# UNITED STATES PATENT AND TRADEMARK OFFICE

APPLICATION NO.	FILING DATE	FIRST NAMED INVENTOR	ATTORNEY DOCKET NO.	CONFIRMATION NO.
10/693,850	10/23/2003	Steven M. Arnold	LEW 17,494-1	3672

## Office Action Summary

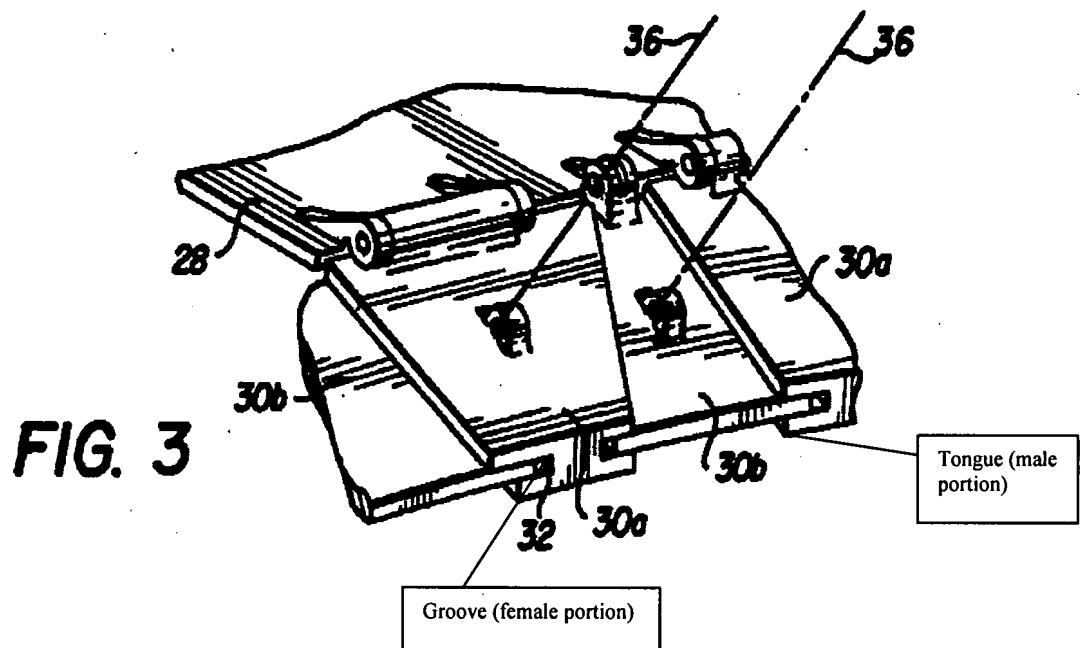
Lewis teaches (particularly figures 2-3) a variable area nozzle for use in a gas turbine engine comprising: a concentric support 28; a plurality of trapezoidal flaps (30a, 30b) circumferentially and rotatably mounted to said concentric support forming a nozzle positionable between a first position

corresponding to a minimum area nozzle and a second position corresponding to a maximum area nozzle; each of said plurality of trapezoidal flaps engages an adjacent flap sealing said nozzle in all positions between and including said first position corresponding to a minimum area nozzle and a second position corresponding to a maximum area nozzle, wherein said flaps have an interior surface and exterior surface, said surfaces including a contour, an actuator for moving said flaps between said first position and said second position, each of said flaps having a male tongue and a female groove portion (see marked up figure 3 below), said minimum area nozzle forming a conical shape.
